TECHNICAL BULLETIN

POINT BLANK 2

Two problems have been identified on games with the following serial numbers:-

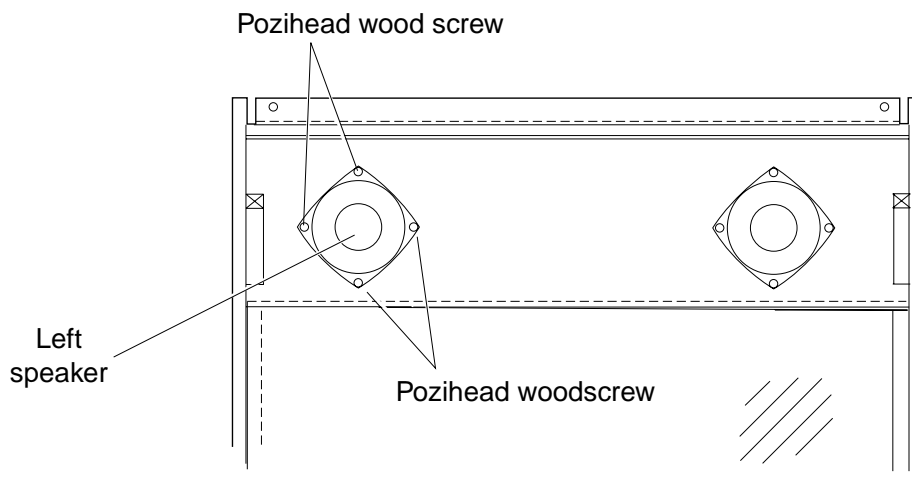
1. **SWITCH THE GAME OFF.**
2. Remove 5 off security screw (M5x20) and remove the speaker mesh.

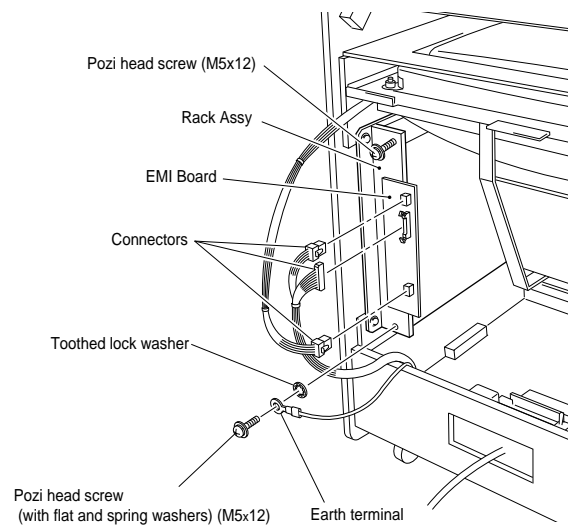
The loudspeakers have been wired 'out of phase' resulting in a loss of bass tone.

3. Remove 4 off pozi head wood screws and remove the left speaker only sufficiently to access the speaker connections.
Note: Take care not to damage the speaker cone.

4. Disconnect the speaker.
5. Cut off the 0.110" (smallest) receptacle from the white/violet wire and replace it with the supplied 0.187" receptacle.
6. Cut off the 0.187" receptacle from the white/red wire and replace it with the supplied 0.110" receptacle.
7. Reconnect the speaker and reassemble in reverse order.

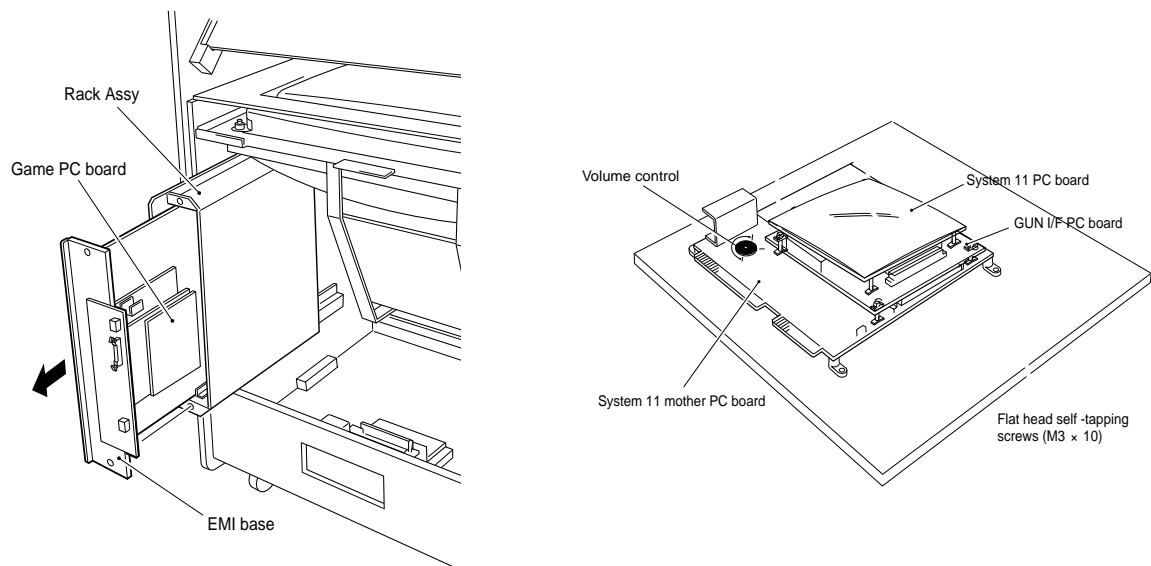
The master volume has been set too low.

8. Open the back door and disconnect the connectors from the EMI Board.
9. Remove 2 off pozi head screws (M5x12) from the rack assembly, taking care not to lose the toothed washer behind the earth terminal.

10. Carefully withdraw the game pcb assembly from the rack assembly only sufficient to gain access to the volume control on the System 11 Mother PC Board.

11. Turn the volume control clockwise to approx $\frac{3}{4}$ of its travel.
12. Ensure that the System 11 Mother PC Board edge connection is fully seated in the edge connector housing of the EMI PC Board and reassemble in reverse order.
